# Manami Fashion Ltd (9705)

06.April.2014

**ACCORD**  
on Fire and Building Safety in Bangladesh

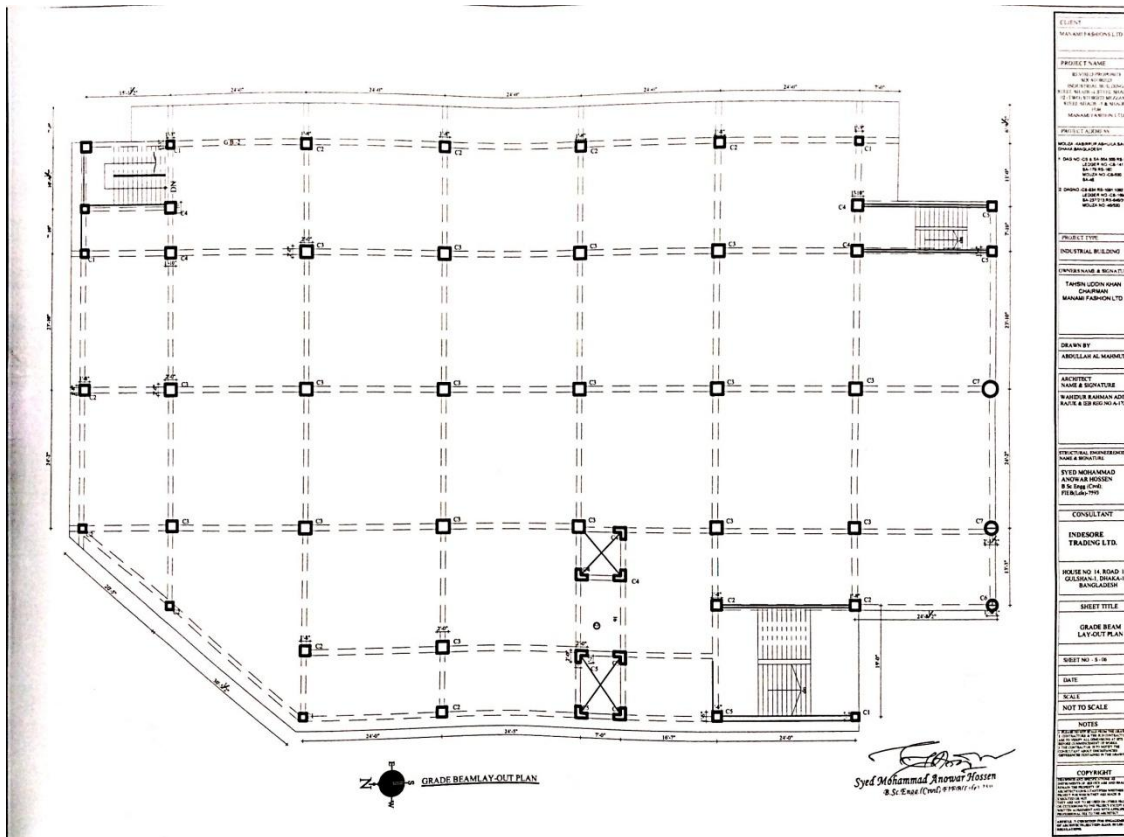
Poor steel connection details between sheds one and two.

Priority 2 Concern

- Carry out an engineering assessment to determine the extent of remedial works required.

- Carry out remedial works, strengthening beams and connections where required.
